REQUEST FOR PROPOSALS
FEASIBILITY STUDY OF BUILDING 611 AT THE PHILADELPHIA NAVY YARD
ADDENDUM 2 – Q & A
MARCH 1, 2024

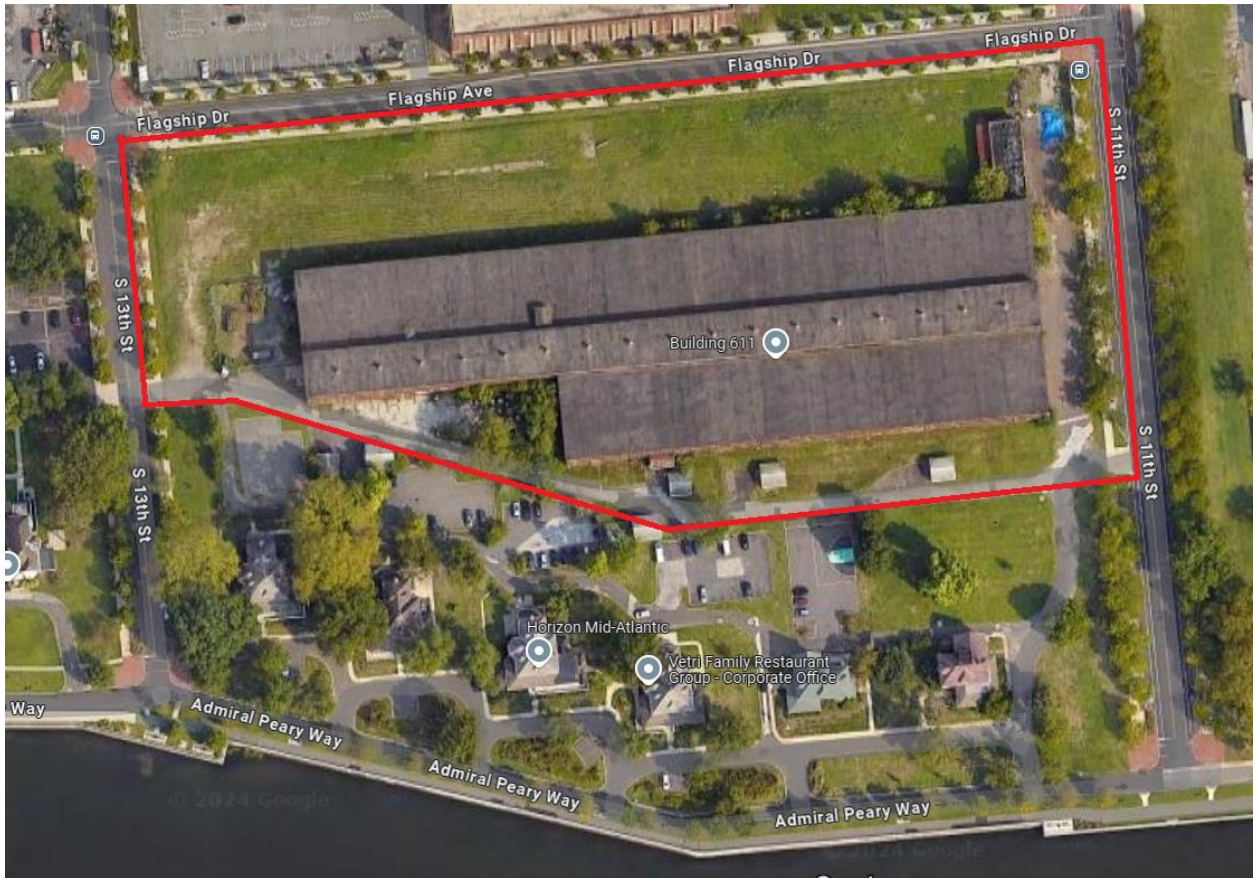
17. What is the scope of site development? Do we include extending 12th street between the 2 building sections?, How far is the site extended beyond the building footprints?

The 12th Street Connection is included in the RFP for consultants to understand the holistic vision of this redevelopment area. This is a building feasibility study to determine the feasibility of bisecting Building 611 through adaptive reuse. The extension of 12th Street is only relevant in terms of how much to cleave the structure.

For the purposes of this study, consultants should assume this is the site.
